Contract #: 04-0120F4Cty: SF/ALA Rte: 80 PM: 13.2/13.9File #: 69.25B**QUALITY ASSURANCE -- NON-CONFORMANCE REPORT****Location:** Changxing Island, Shanghai, P.R. China**Report No:** NCR-000671**Prime Contractor:** American Bridge/Fluor Enterprises, a JV**Date:** 02-Feb-2010**Submitting Contractor:** Zhenhua Port Machinery Company, Ltd (ZPMC), Changxing Island**NCR #:** ZPMC-0639**Type of problem:**

**Reference Description:** Missed UT indication by QC on Segment 9AE, Side Panel Welds**Description of Non-Conformance:**

<b>To:</b>	AMERICAN BRIDGE/FLUOR, A JV 375 BURMA ROAD OAKLAND CA 95607	<b>Date:</b>	03-Feb-2010
<b>Dear:</b>	Mr. Charles Kanapicki	<b>Contract No:</b>	04-0120F4 04-SF-80-13.2 / 13.9
<b>Attention:</b>	Mr. Thomas Nilsson Project/Fabrication Manager	<b>Job Name:</b>	SAS Superstructure
<b>Subject:</b>	NCR No. ZPMC-0639	<b>Document No:</b>	05.03.06-000630

**Job Name:** SAS Superstructure

WELD NUMBER: SEG3002A-001

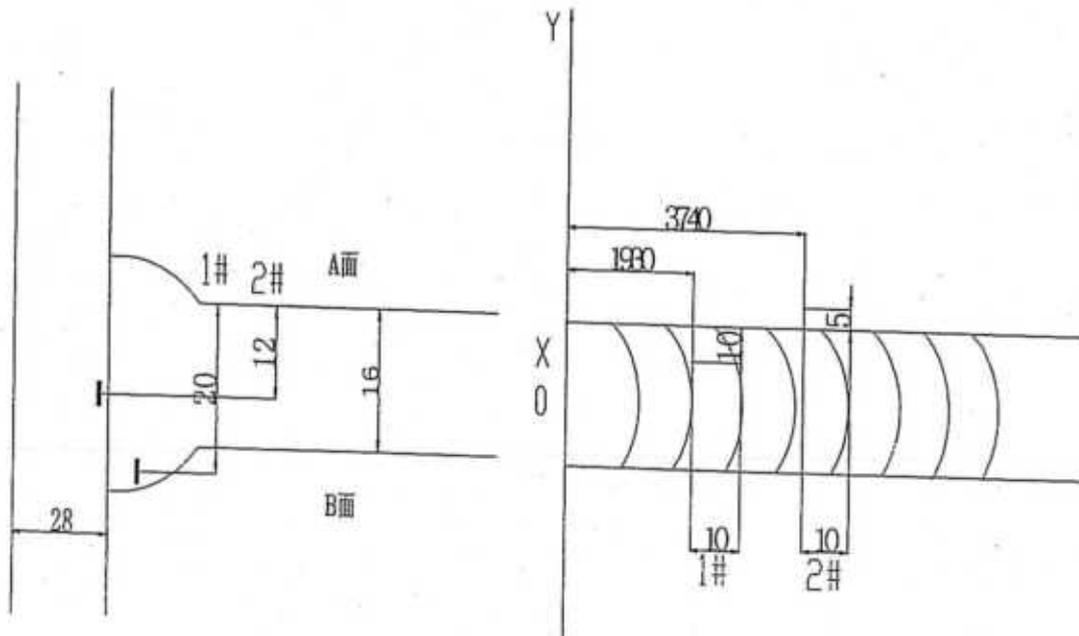
Description of welding discontinuity:

Rejected indication found by ultrasonic inspection is less than the maximum allowance aggregate length.

1. Did not clear the weld pass completely in time.

1. Gouge or grind from nearer side from metal edge ( $D \leq 0.65T$ , "D" is depth of defects, "T" is thickness of metal) to remove all defects;

2. Follow repair WPS for joint preparation, preheat, and weld deposit;

3. Verify with VT no defects remain in the weld joint prior to welding;

4. Grind the repaired area flush with base metal or the adjacent weld;

5. Perform UT inspection to the weld along with 50mm on each end of the repair area;

(UT探伤发现的缺陷总长度小于最大允许长度。) SEG048\*-008

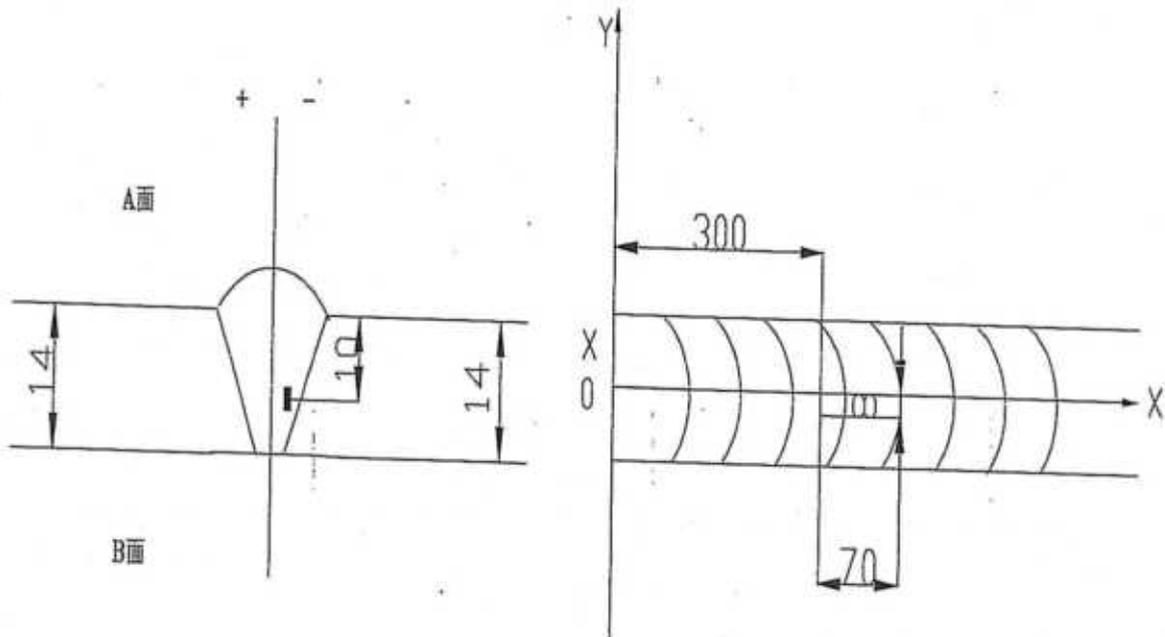
Description of welding discontinuity:

Rejected indication found by ultrasonic inspection is less than the maximum allowance aggregate length.

1. Gouge or grind from nearer side from metal edge ( $D \leq 0.65T$ , "D" is depth of defects, "T" is thickness of metal) to remove all defects;
2. Follow repair WPS for joint preparation, preheat, and weld deposit;
3. Verify with VT no defects remain in the weld joint prior to welding;
4. Grind the repaired area flush with base metal or the adjacent weld;
5. Perform UT inspection to the weld along with 50mm on each end of the repair area;

(UT探伤发现的缺陷总长度小于最大允许长度。) SEG050A-003

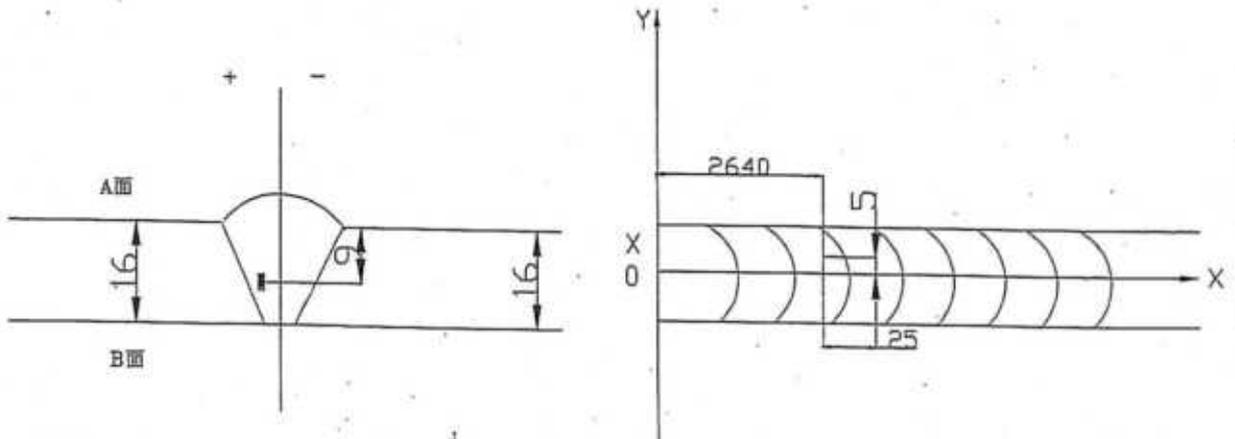
Description of welding discontinuity:

Rejected indication found by ultrasonic inspection is less than the maximum allowance aggregate length.

1. Gouge or grind from nearer side from metal edge ( $D \leq 0.65T$ , "D" is depth of defects, "T" is thickness of metal) to remove all defects;
2. Follow repair WPS for joint preparation, preheat, and weld deposit;
3. Verify with VT no defects remain in the weld joint prior to welding;
4. Grind the repaired area flush with base metal or the adjacent weld;
5. Check the welds according to the working drawings;

(UT探伤发现的缺陷总长度小于最大允许长度。) SEG050A-003

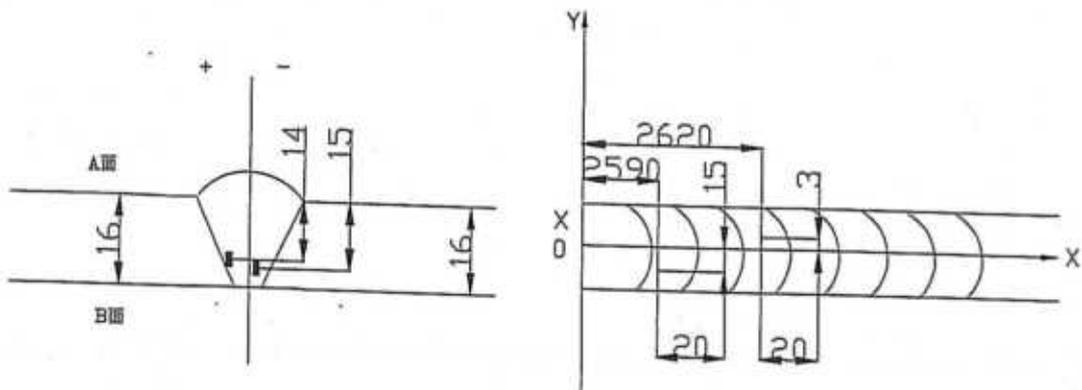
Description of welding discontinuity:

Rejected indication found by ultrasonic inspection is less than the maximum allowance aggregate length.

1. Gouge or grind from nearer side from metal edge ( $D \leq 0.65T$ , "D" is depth of defects, "T" is thickness of metal) to remove all defects;

3. Verify with VT no defects remain in the weld joint prior to welding;
